**Subject: Amendment 3, M-77-211 – Adequacy Review Response  
Continental Materials Corporation, Transit Mix Aggregates, Castle Concrete  
Pikeview Quarry**

Transit Mix Aggregates is forwarding five copies of the revised Permit Amendment 3 permit application for Pikeview Quarry in response to October 15, 2012 Adequacy Review Comment letter.

EXHIBIT F-4  
RECLAMATION PHASE 04

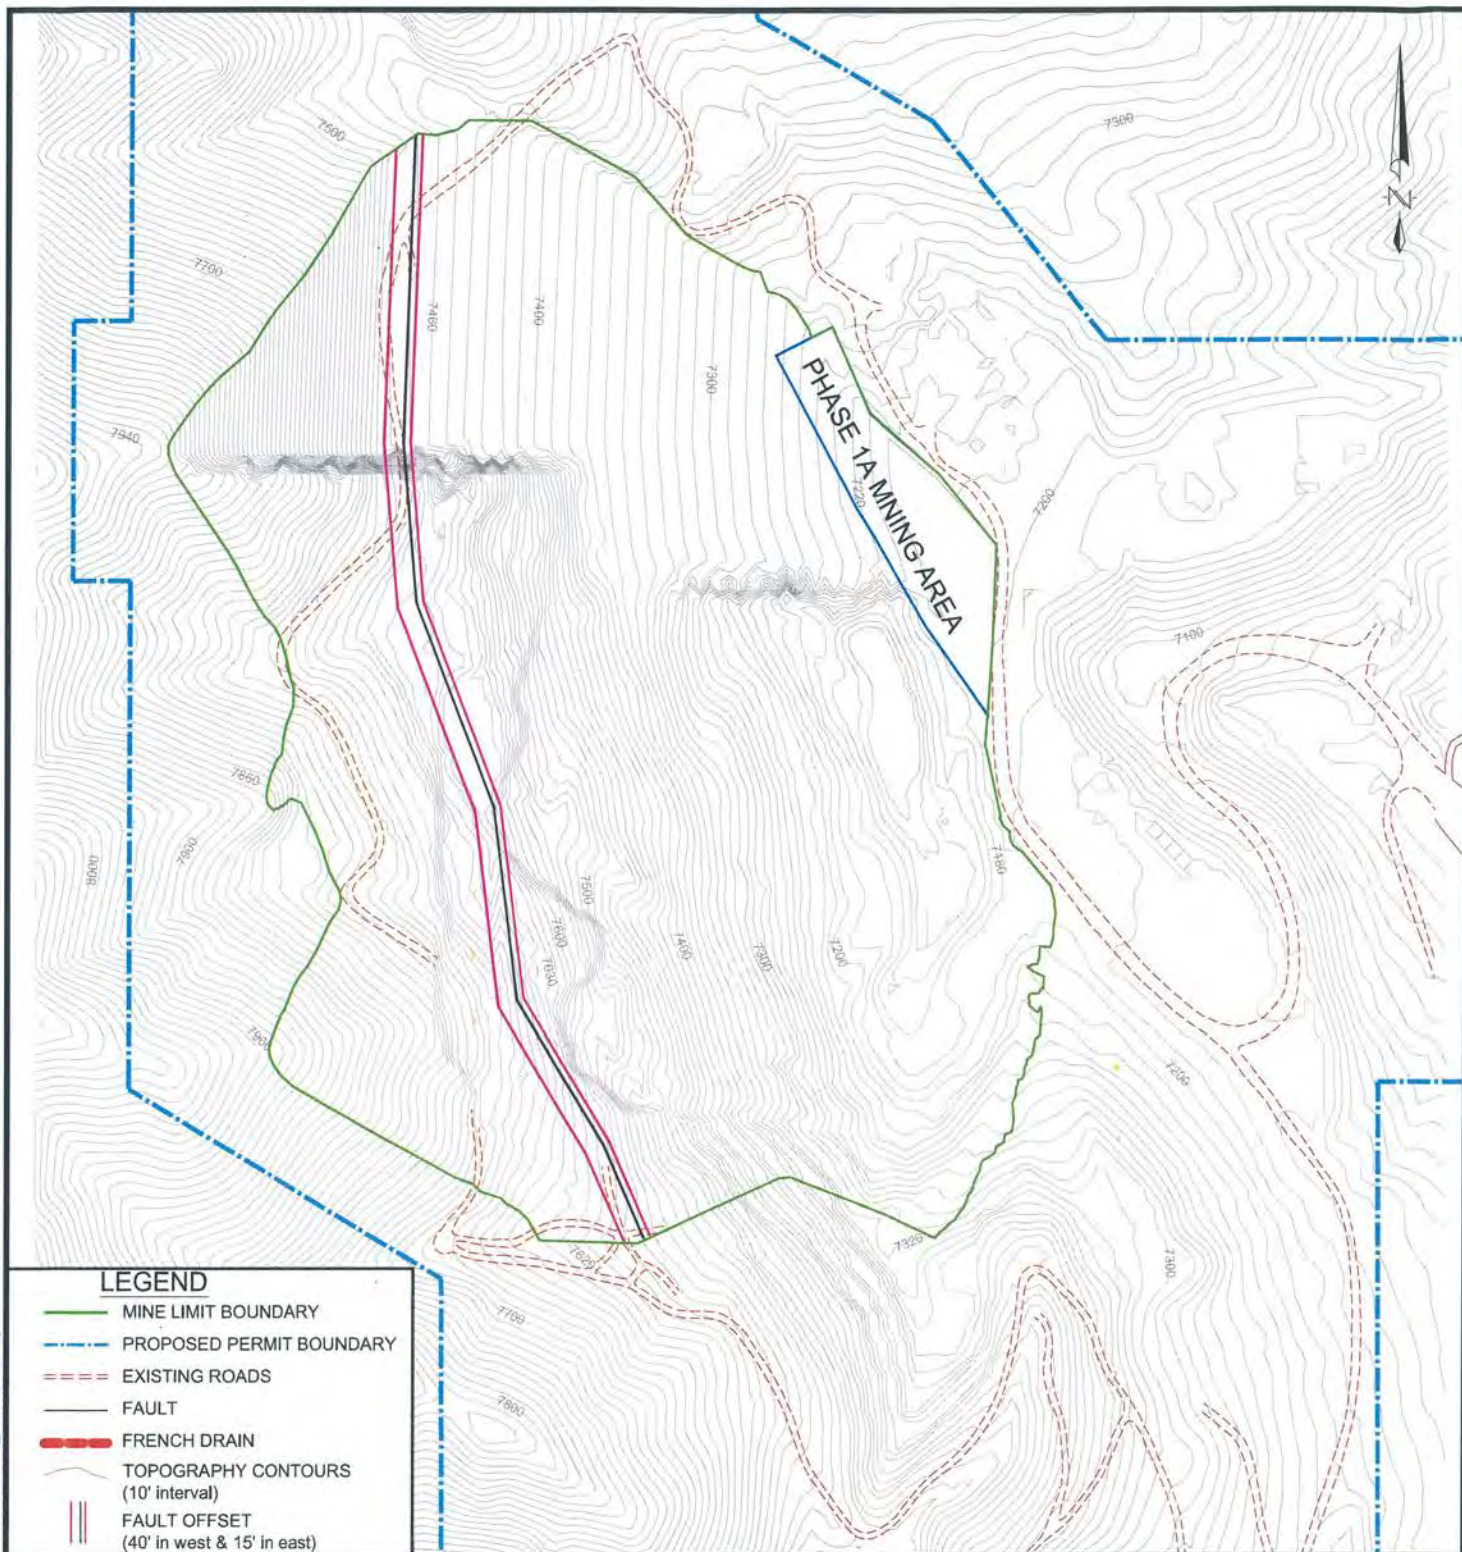
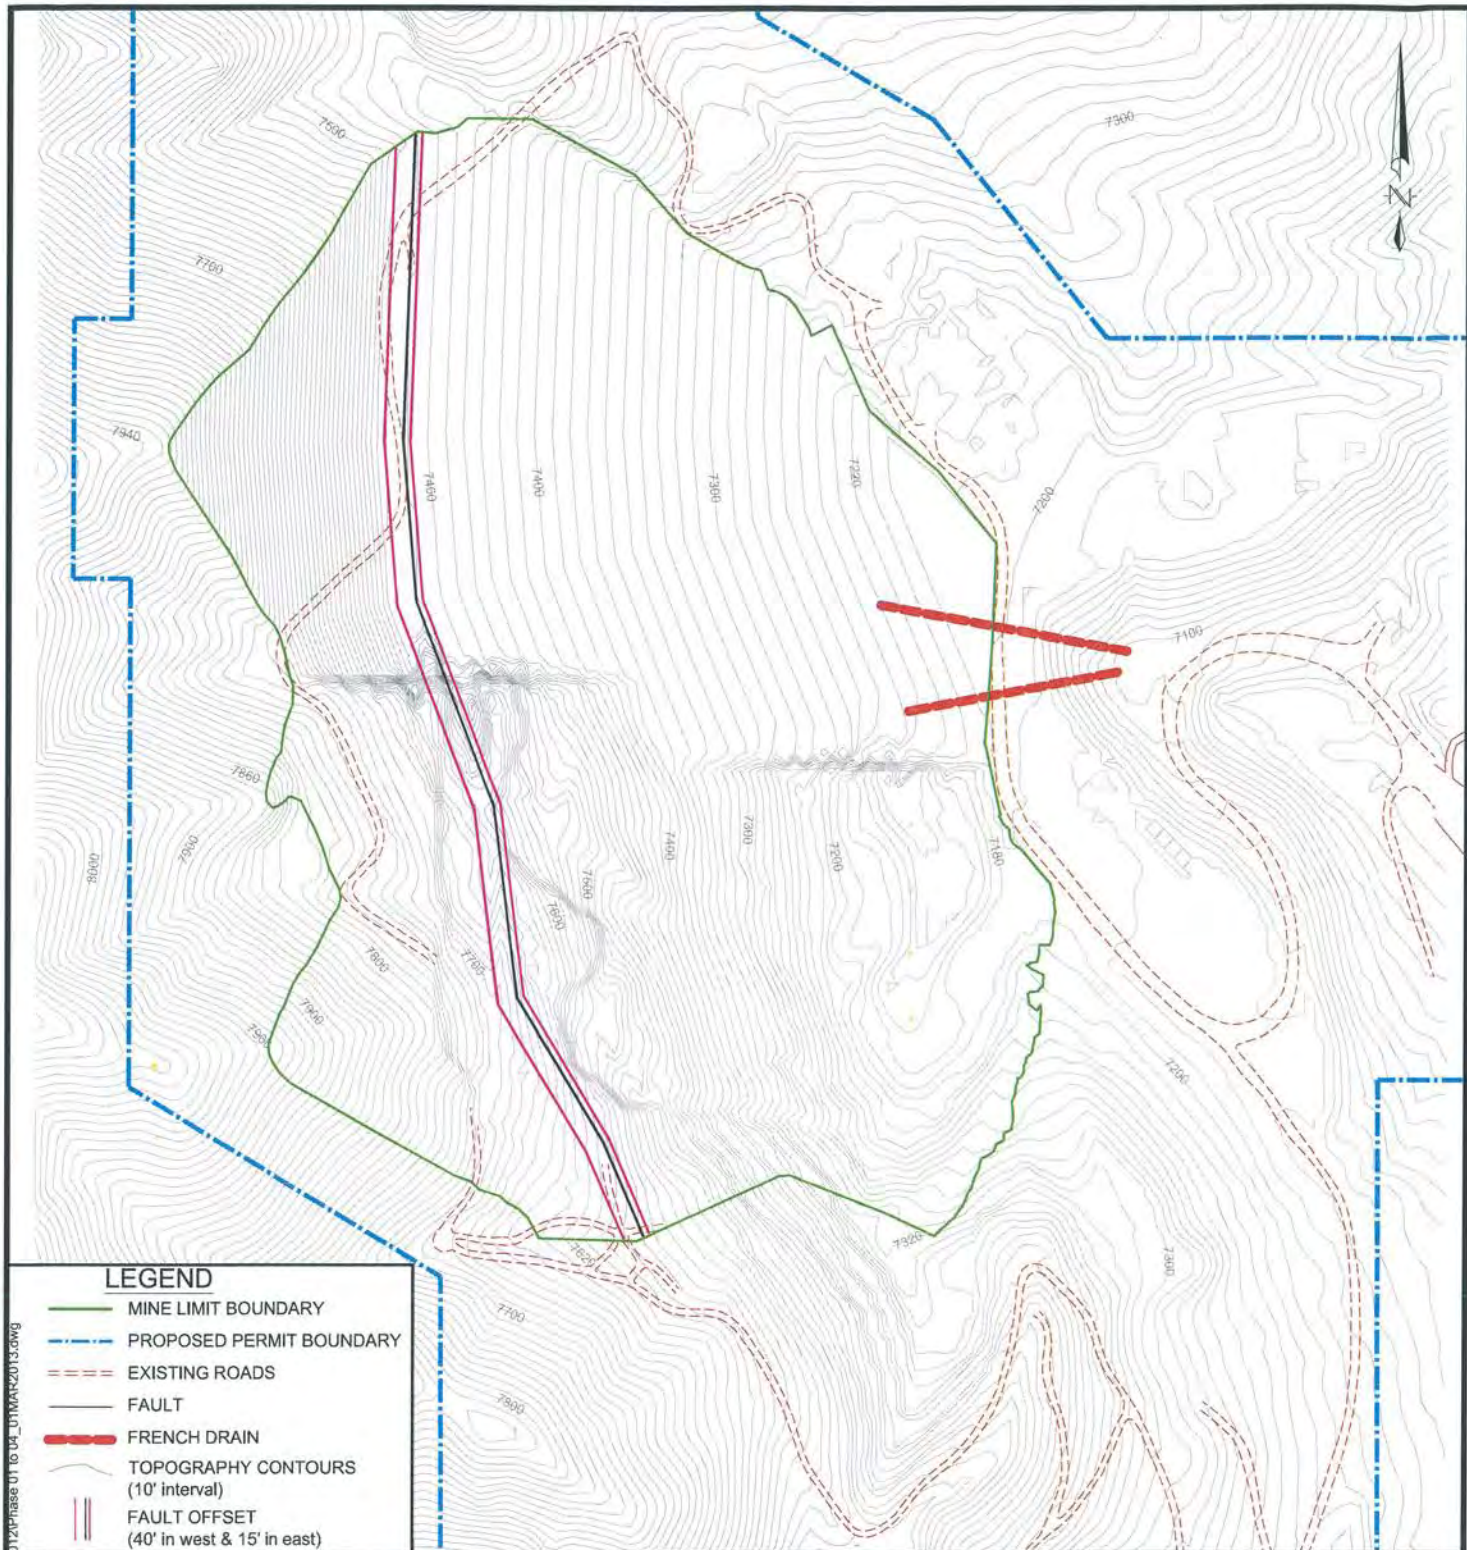
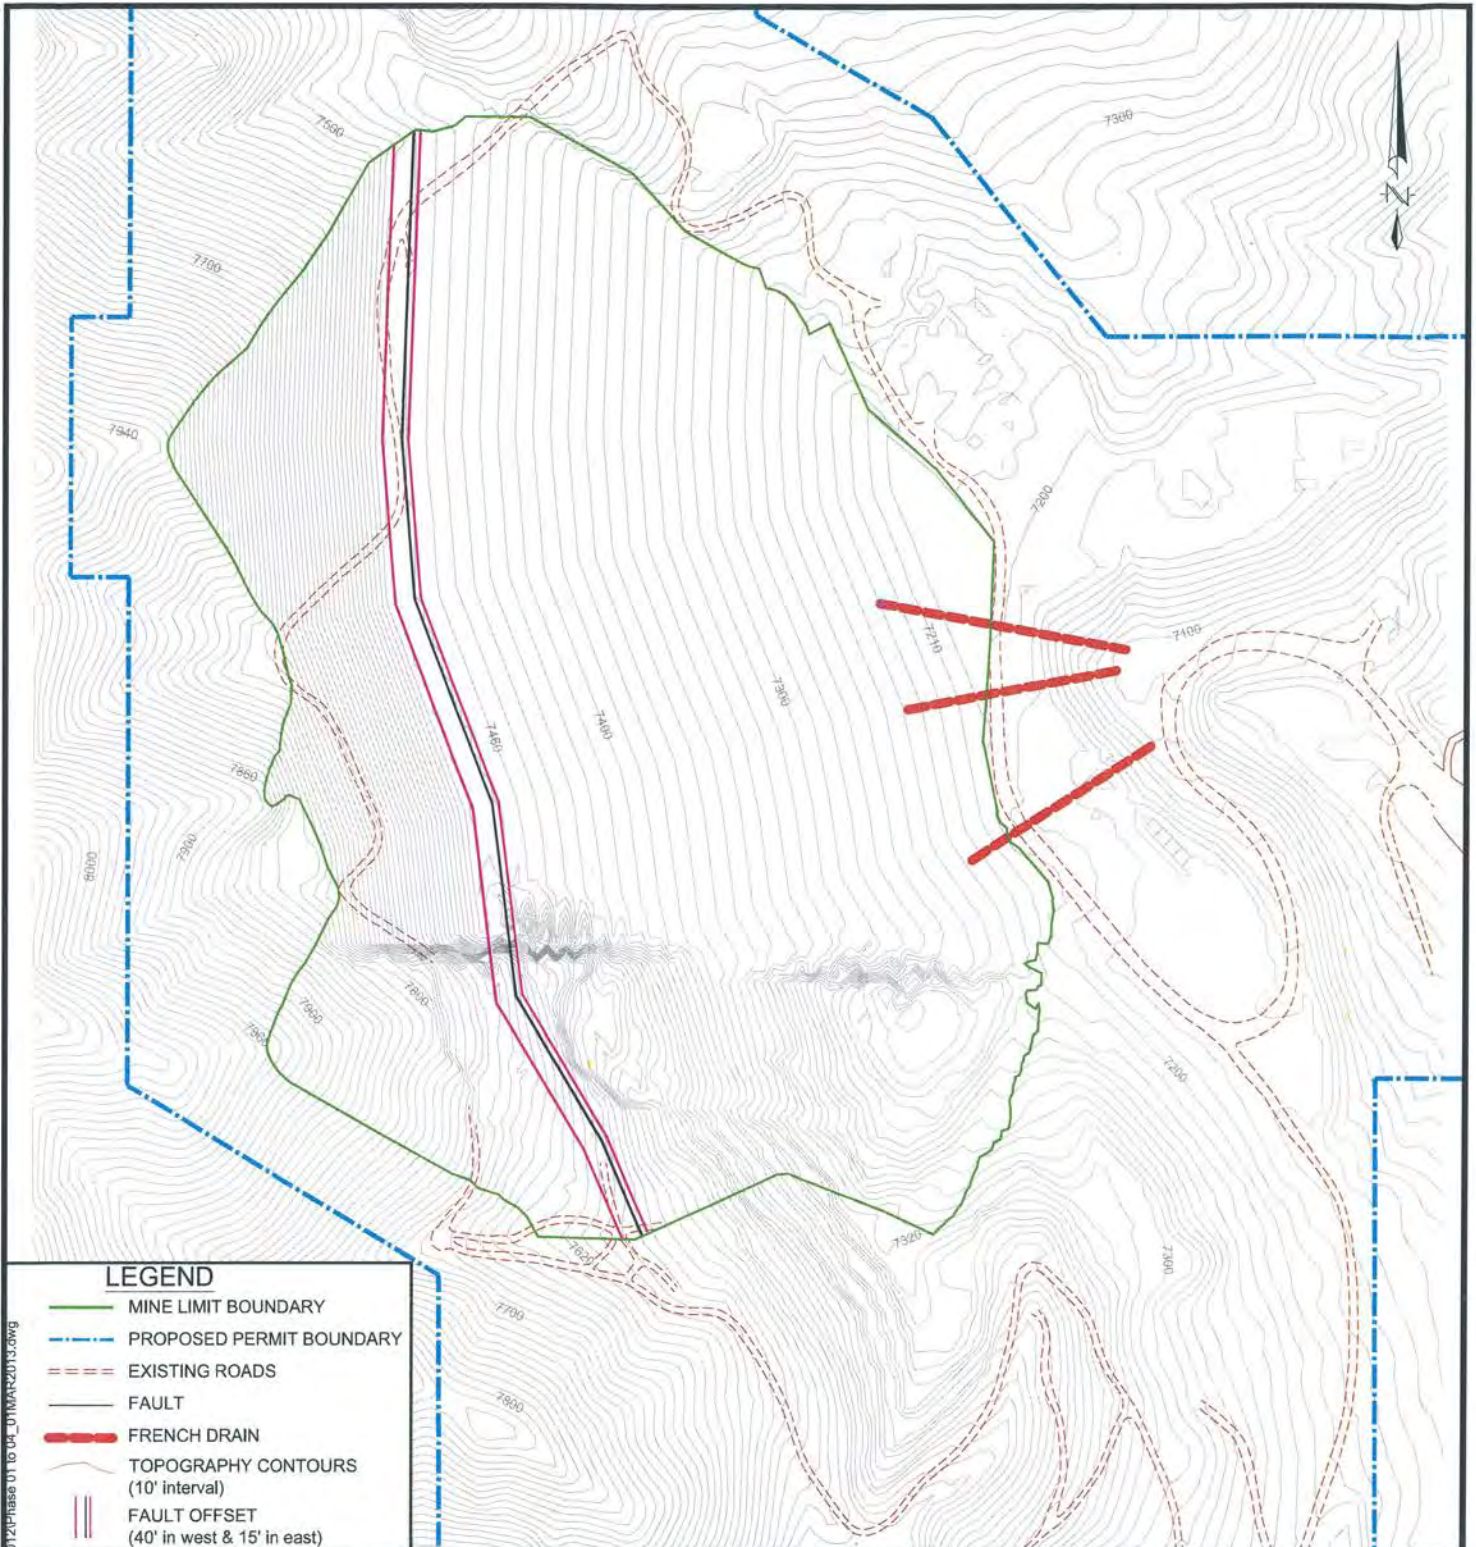
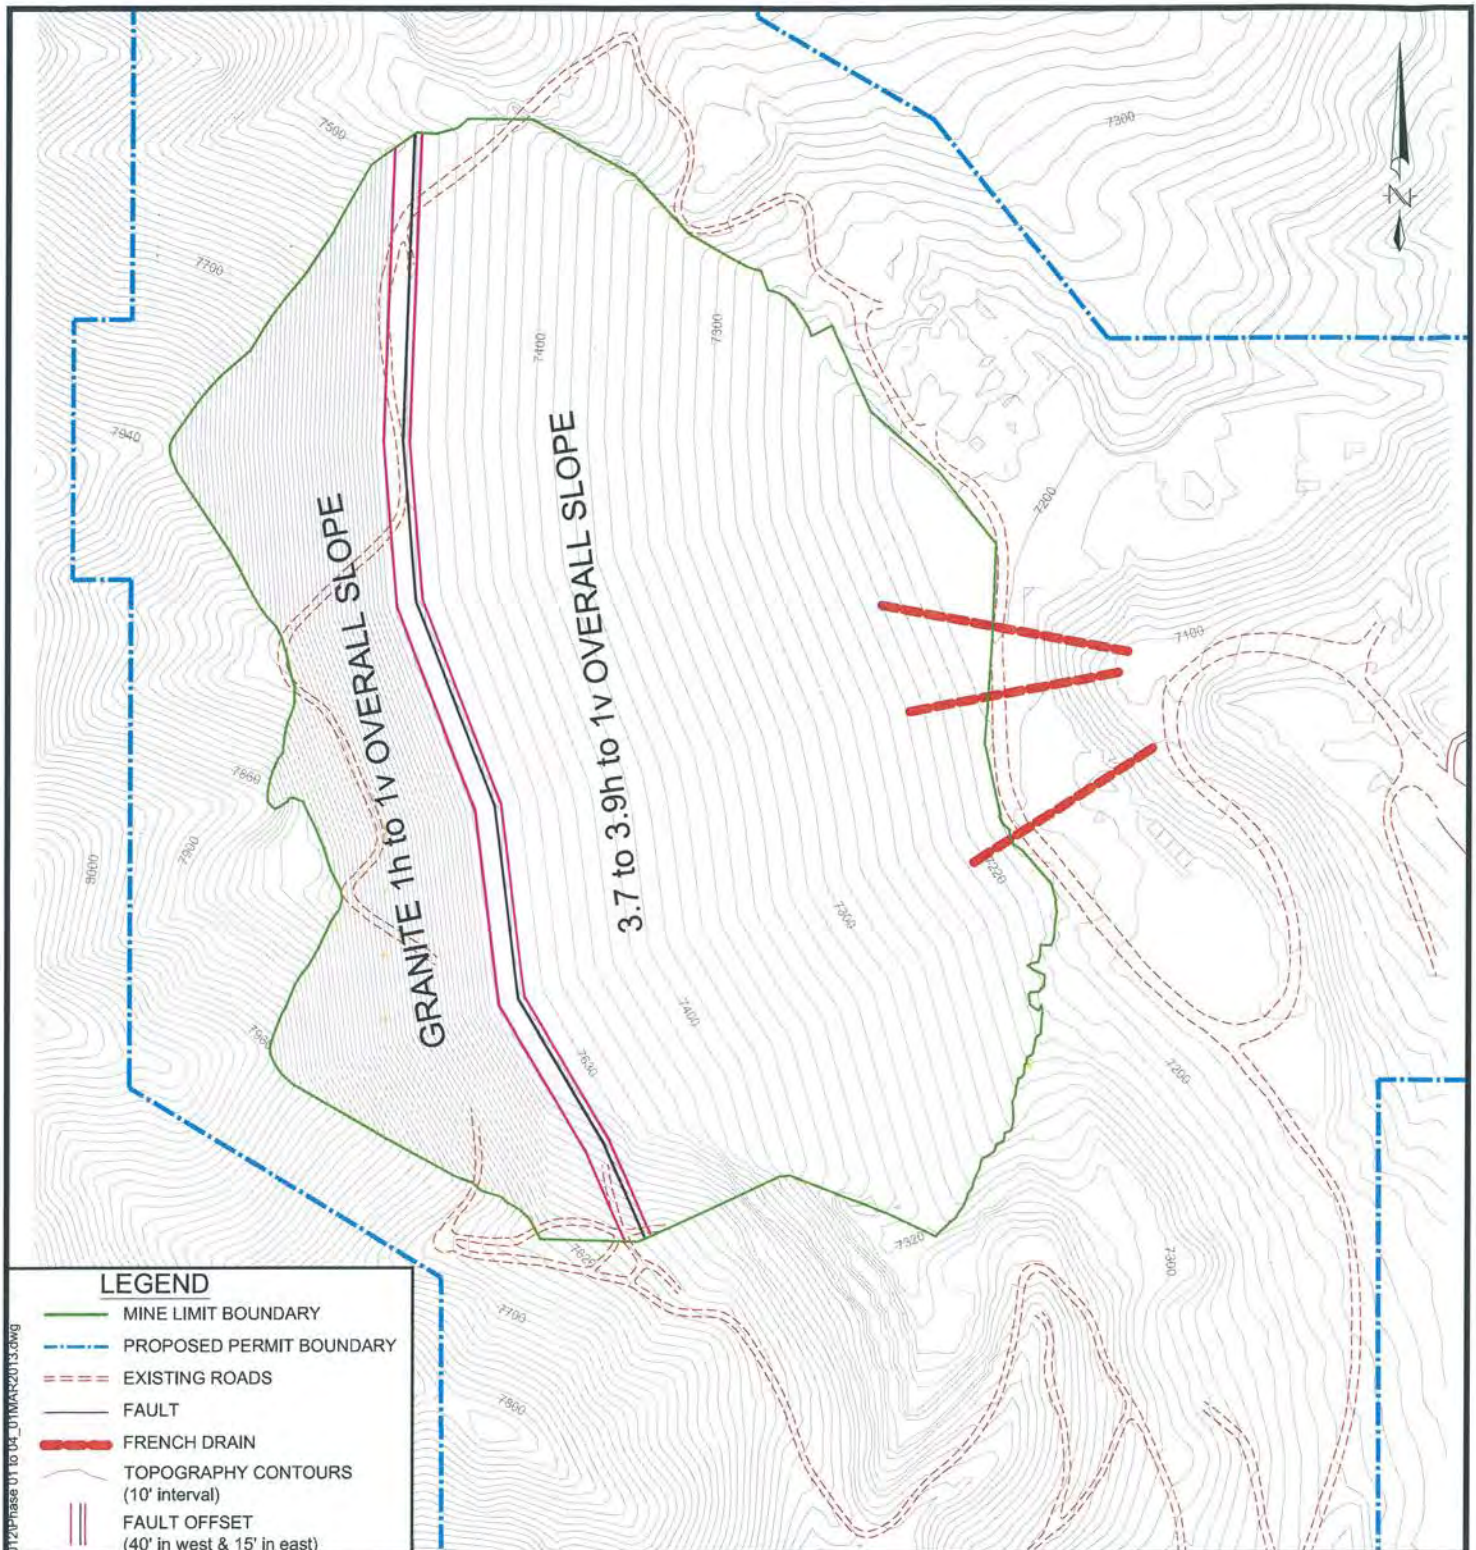
Please provide the reclamation plan map in accordance with Rule 6.4.6 (a) which shall include the following, “The expected physical appearance of the area of the affected land, correlated to the proposed mining and reclamation timetables. The map must show proposed topography of the area with contour lines of sufficient detail to portray the direction and rate of slope of all reclaimed lands”.

*Exhibits F-1 through F-4, the Reclamation Plan phase maps have been modified to darken and label the contour lines. The predominant direction of slope is from west to east.*

**TYPICAL FRENCH DRAIN SECTION**

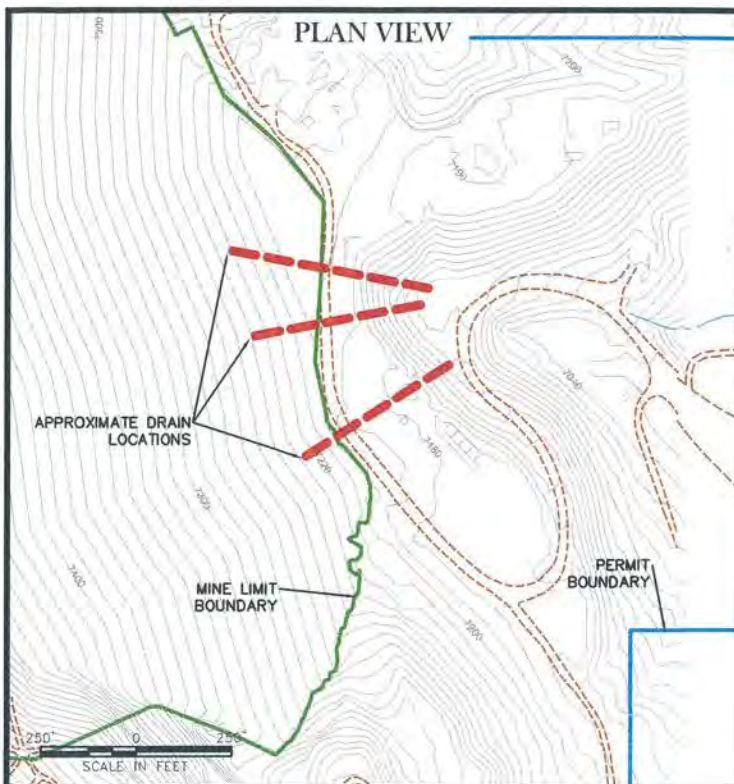
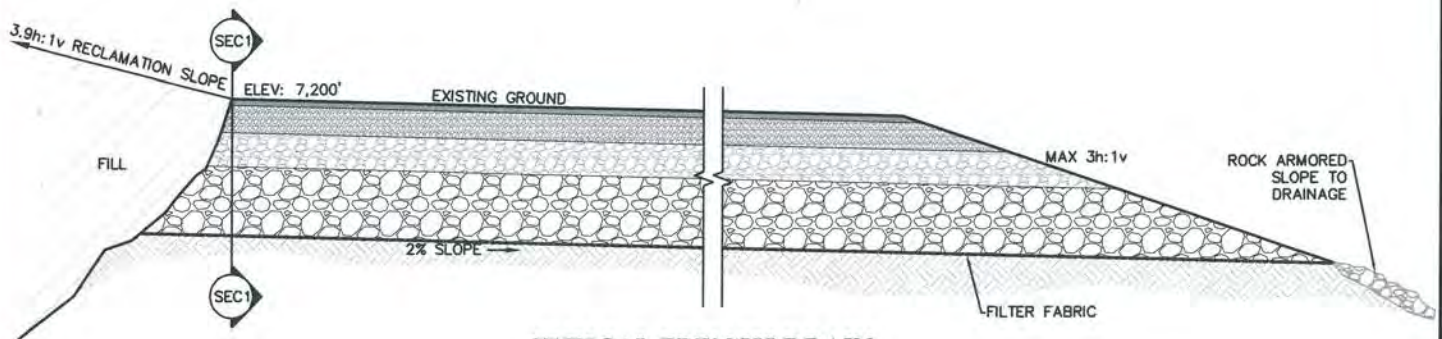
- 3) Please provide a typical design for the proposed diversions and French Drain. No design details were provided with the application.

- 5) Please provide details of the proposed French Drains that will be implemented to limit potential impacts to the slope stability.

The amendment proposes putting a French Drain system at the toe of the fill slope and surface water diversion channels around the final slope. There is not much information provided on the location and design criteria details of these features. Exhibit F (Reclamation Plan) doesn't show these features at all.

- Please provide details and specifications on both the French Drain and the diversion channels.

*A design for the proposed minimum French Drain has been added as Exhibit F-6; it was previously submitted as Exhibit C-6. Exhibit E (page E-4, last paragraph) has been modified to read as follows: “The three proposed French drains will be installed at the current ground surface once backfilling reaches that elevation. These will intercept surface water and direct the flow into the stormwater drainage system. The drains will have a minimum ten-foot width, 2:1 side slopes and be at least 20 feet deep.”*

*A design for the proposed minimum French Drain has been added as Exhibit F-6. Exhibit E (page E-4, last paragraph) has been modified to read as follows: "The three proposed French Drains will be installed at the current ground surface once backfilling reaches that elevation. These will intercept surface water and direct the flow into the stormwater drainage system. The drains will have a minimum ten-foot width, 2:1 side slopes and be at least 20 feet deep."*

*Exhibit F-6 has been modified to show the proposed minimum design details that will be installed across the current mine road connecting the mine office to the aggregate plant area.*
